# Statement of Environmental Effects

## Section 96 Application

100 Bennelong Parkway, Sydney Olympic Park

MOD 2 - Amend building heights to respond to new road infrastructure

**Figure 1: Extent of proposed height increase**

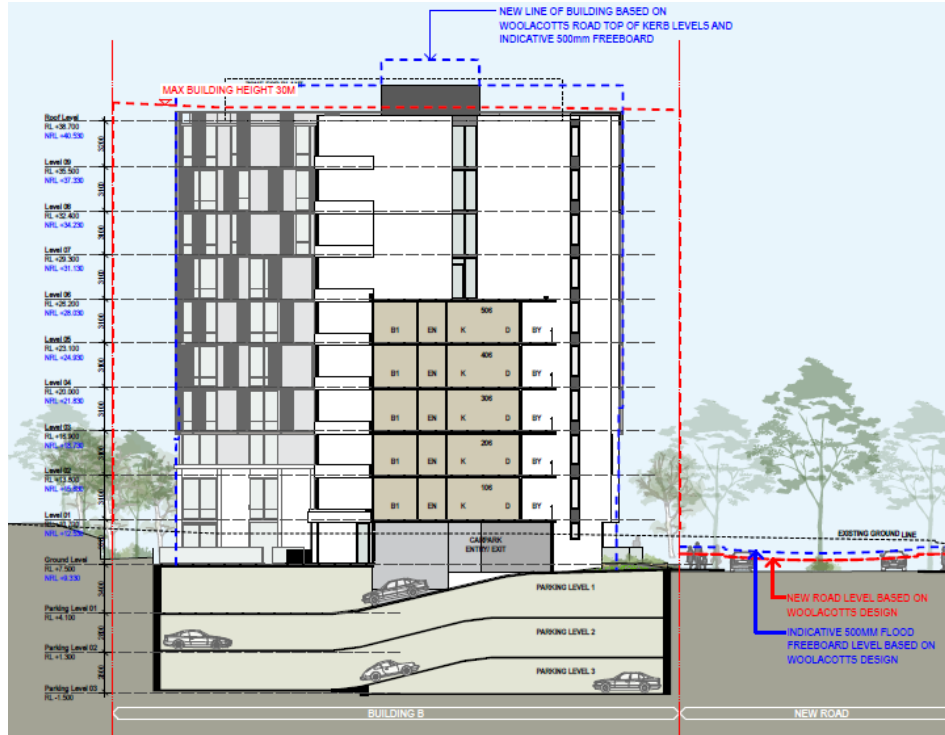
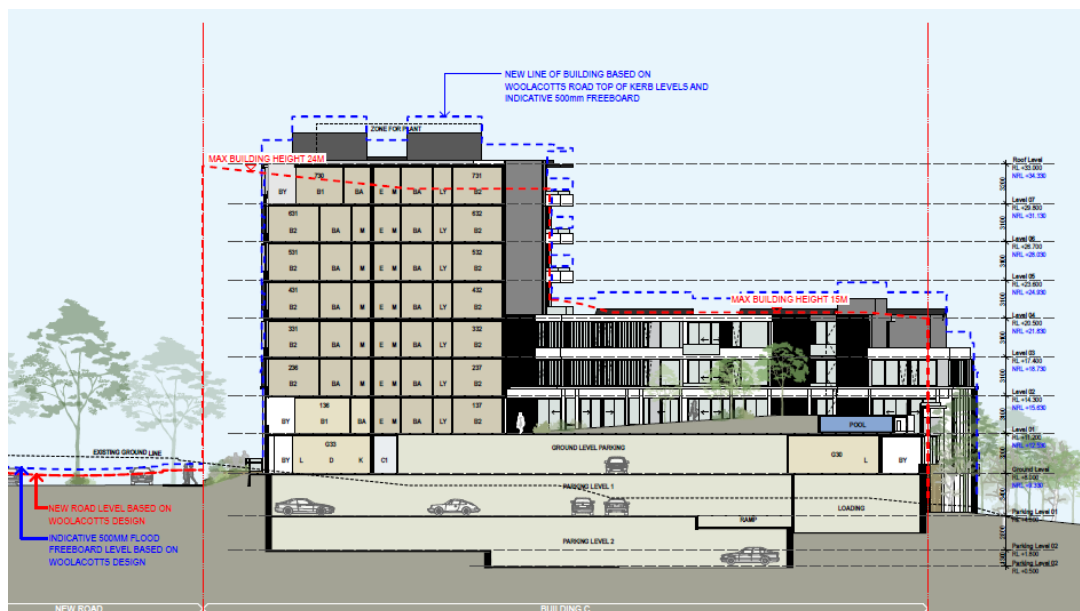
The detailed design of future road infrastructure surrounding the site has also been progressed by the Sydney Olympic Park Authority. To create the new road between Buildings A and B, and Building C excavation of the existing ground is required, this will result in the lowering of the ground levels surrounding the site. The levels originally planned for the new roads were used to inform the design of the proposed development and dictated the ground floor level of the proposal. However, through detailed construction design planning for the road it has been

identified that the extent of excavation required is less than originally planned. This is largely in response to the flood planning levels for the area.

The effect is that the modified ground level of surrounding roadways as depicted on the approved architectural plans is lower than will be constructed. An adjustment of the ground floor level of the development is therefore required to respond to the changed road level.

This is illustrated in **Figure 1** below.

This application seeks a modification to the approved height of the development as depicted on the architectural drawings (**Annexure 1**) to respond to the revised road design. No changes are proposed to the approved building form. The only change being that the development is to be raised to respond to the new road levels.

To respond to the detailed design of new road infrastructure surrounding the site, new development must be raised 1.5 metres above the building levels specified in the DA. As a result new buildings will marginally project above the maximum height limits nominated for the site.
